HARTLAND PUMP STATION No. 1  
FAYETTE Co., KY

September 1, 2015

**PROPOSAL No. 1A - COMPLETE PUMP DISCHARGE PIPING FROM NEW PUMP BASE & TIE-IN AT EXISTING FORCE MAIN CONNECTION. ADD CROSS OVER CONNECTION AS SHOWN IN PROPOSED DRAWING.**

PLANNED ALIGNMENT  
PROPOSED ALIGNMENT

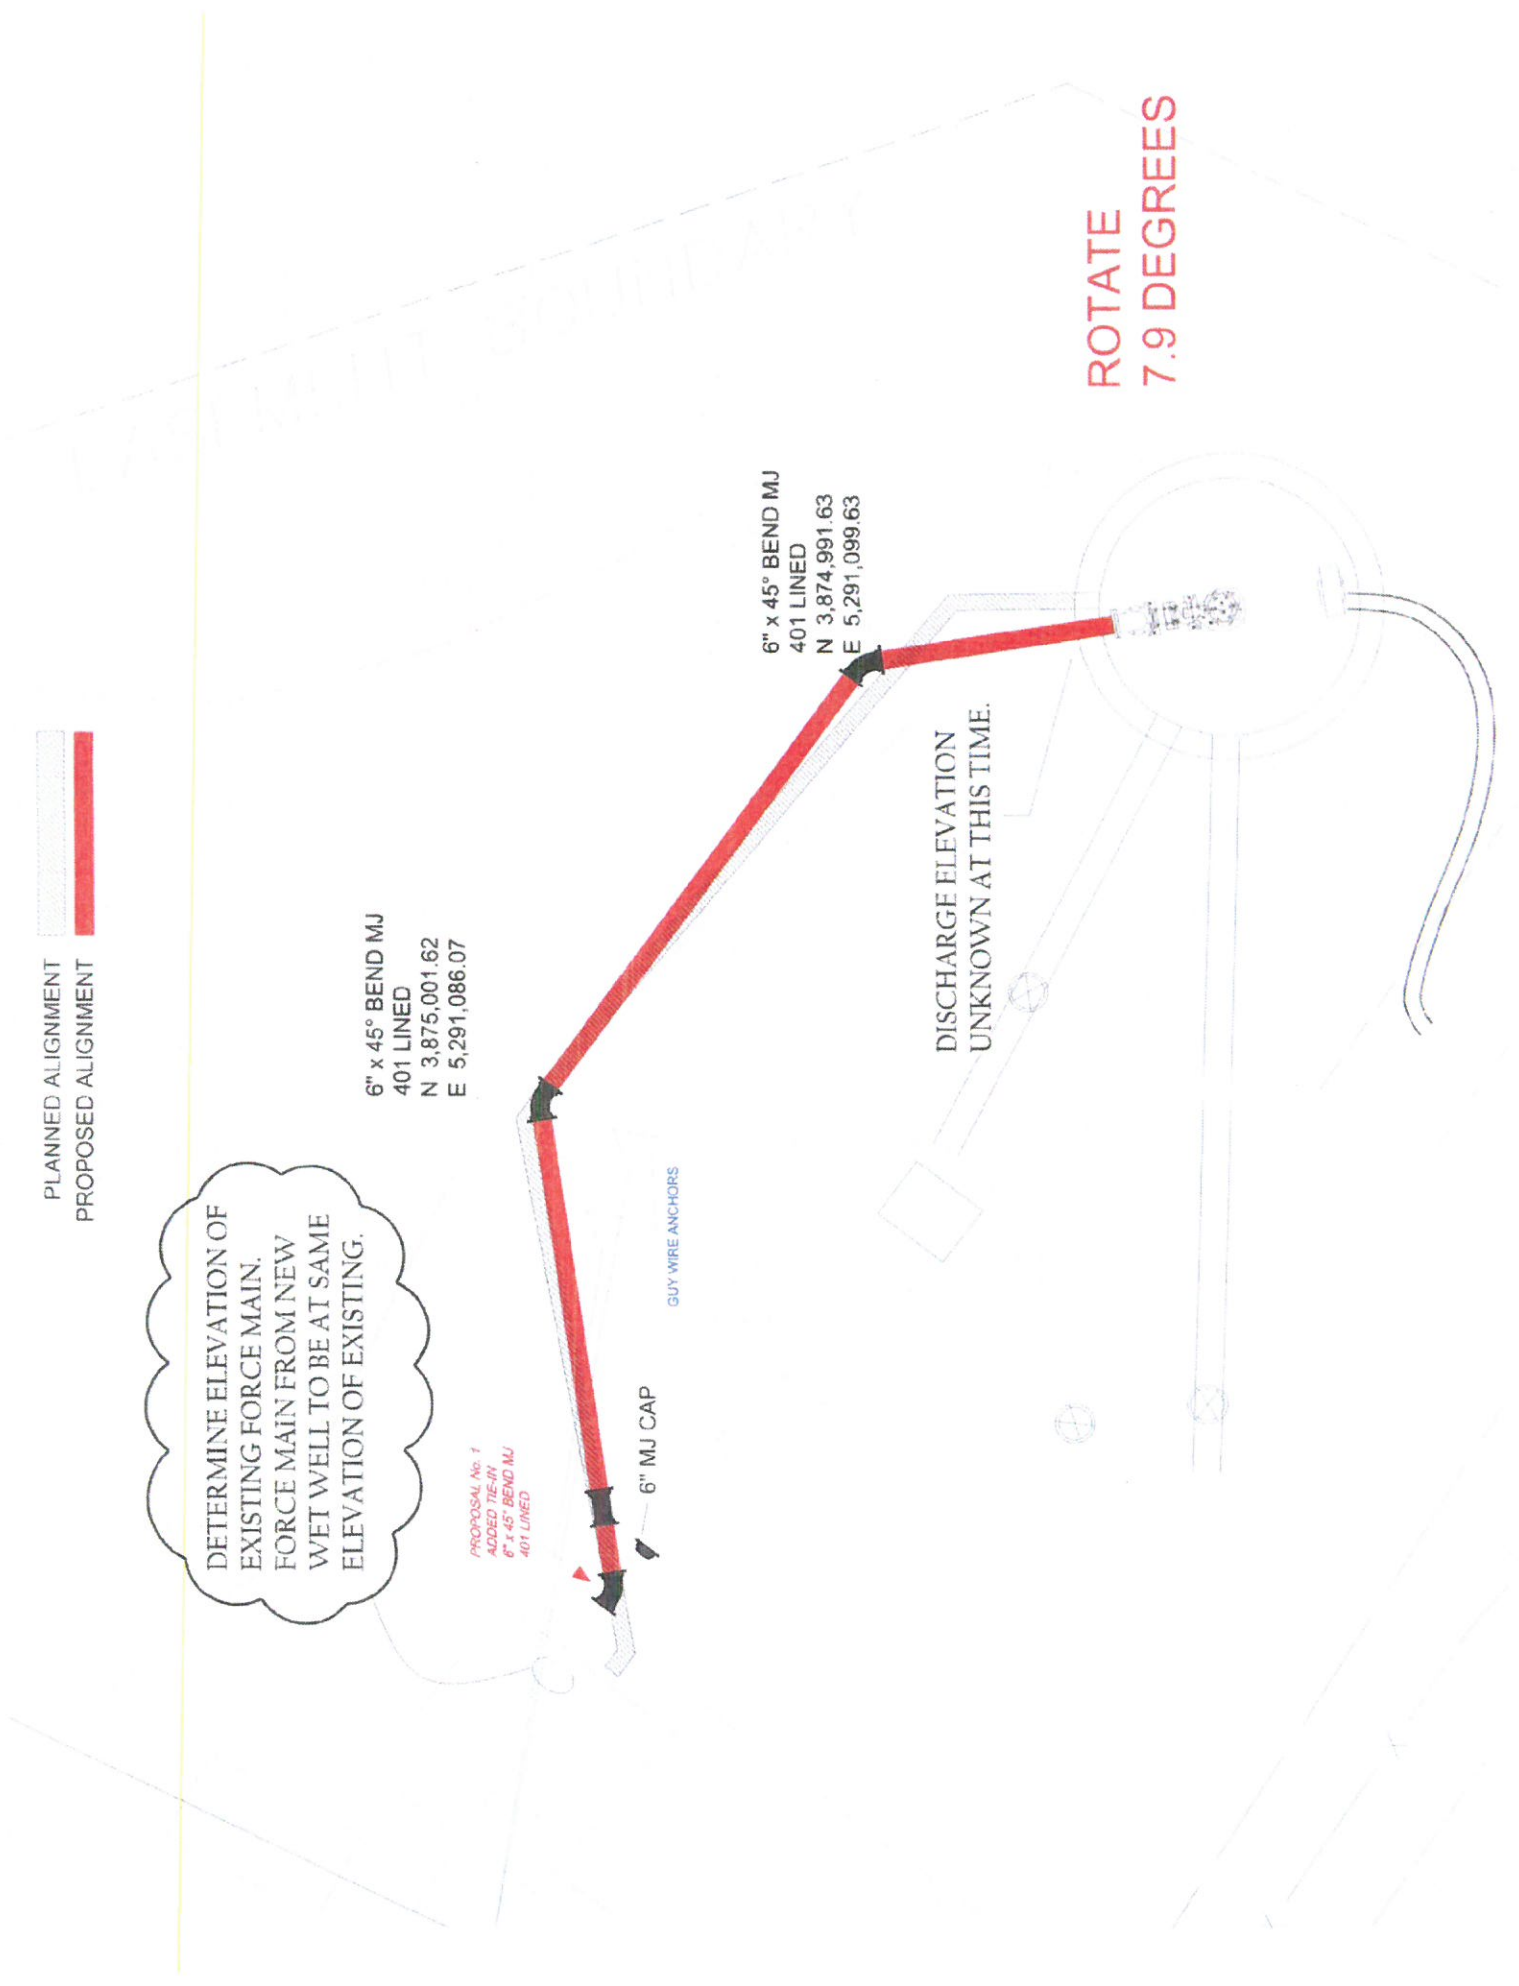
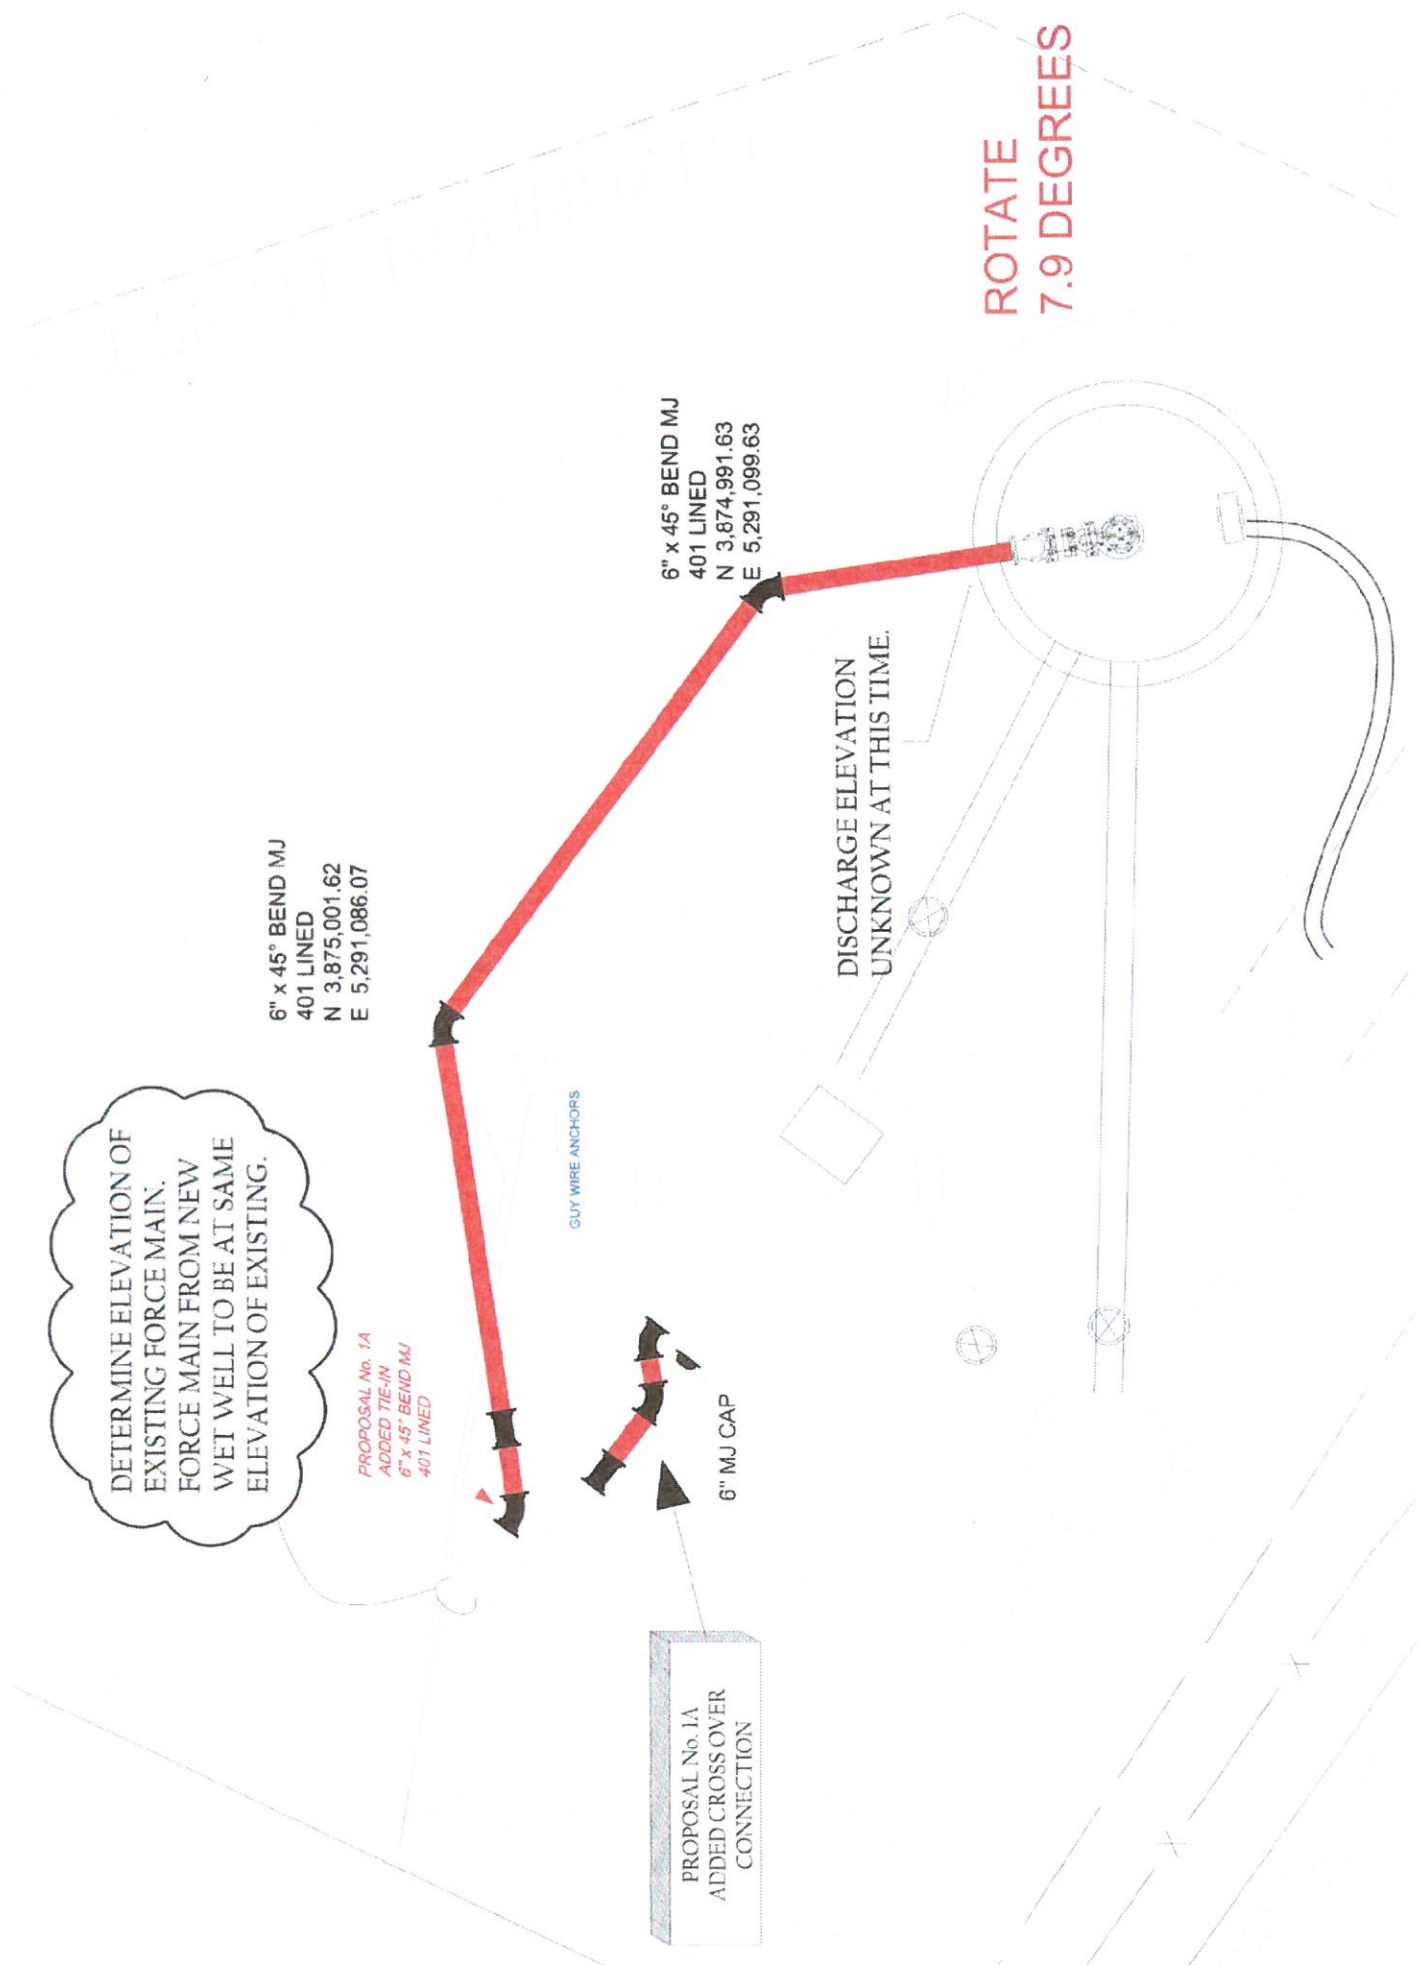
DETERMINE ELEVATION OF EXISTING FORCE MAIN. FORCE MAIN FROM NEW WET WELL TO BE AT SAME ELEVATION OF EXISTING.

PROPOSAL No. 1  
ADDED TIE-IN  
6" x 45° BEND MJ  
401 LINED

DISCHARGE ELEVATION  
UNKNOWN AT THIS TIME.

ROTATE  
7.9 DEGREES

PROPOSAL No. 1A  
ADDED TIE-IN  
6" x 45° BEND MJ  
401 LINED

PROPOSAL No. 1A  
ADDED CROSS OVER  
CONNECTION

DISCHARGE ELEVATION  
UNKNOWN AT THIS TIME.

# HARTLAND No. 1 PROPOSED DISCHARGE PIPING CHANGE

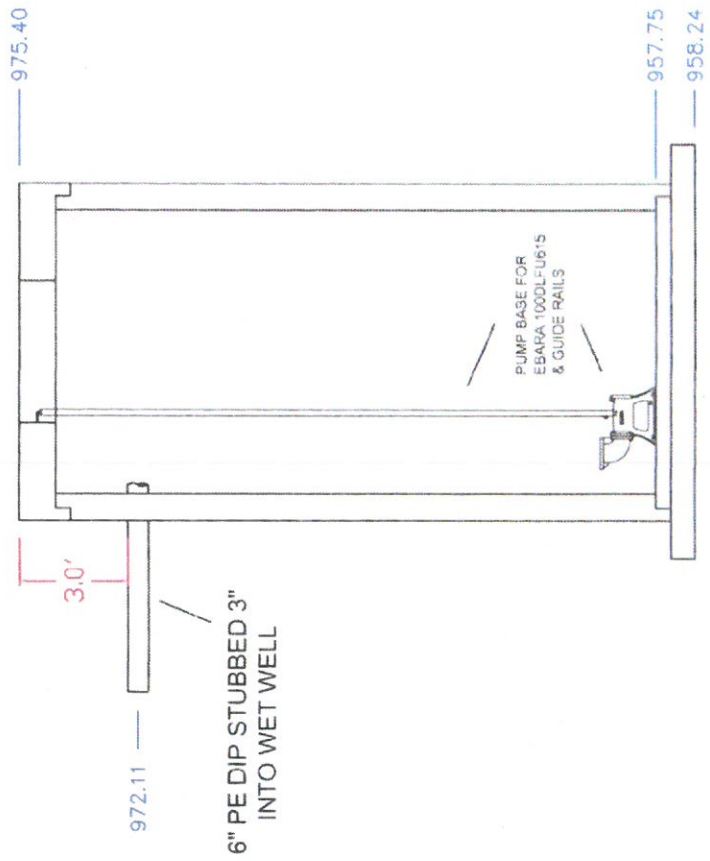
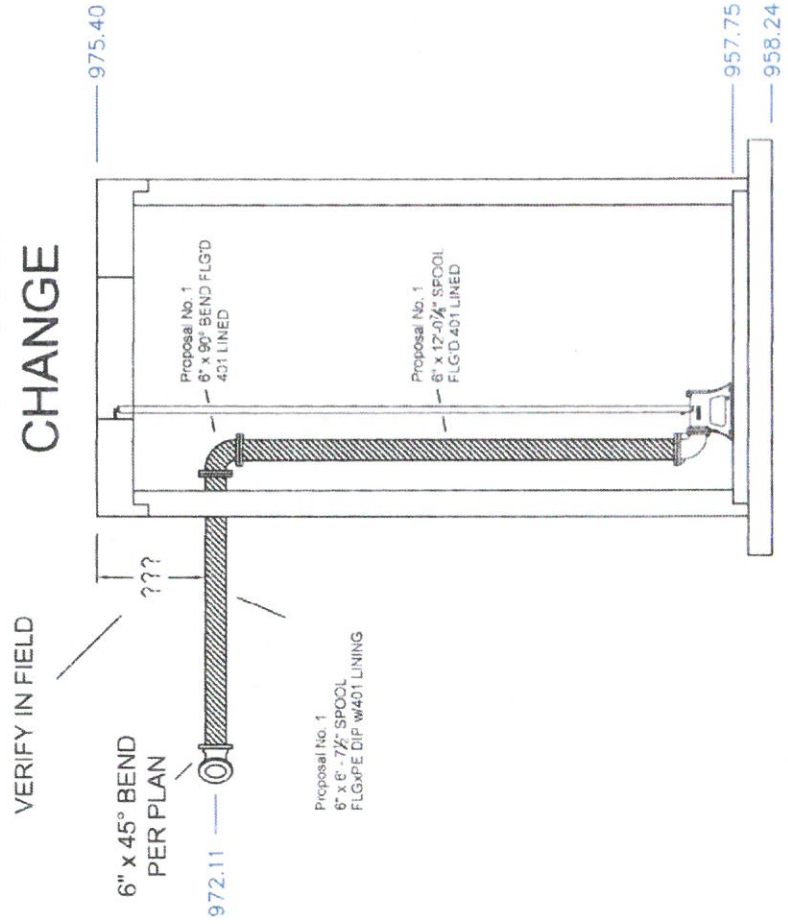
## ORIGINAL PLAN

## PROPOSED CHANGE
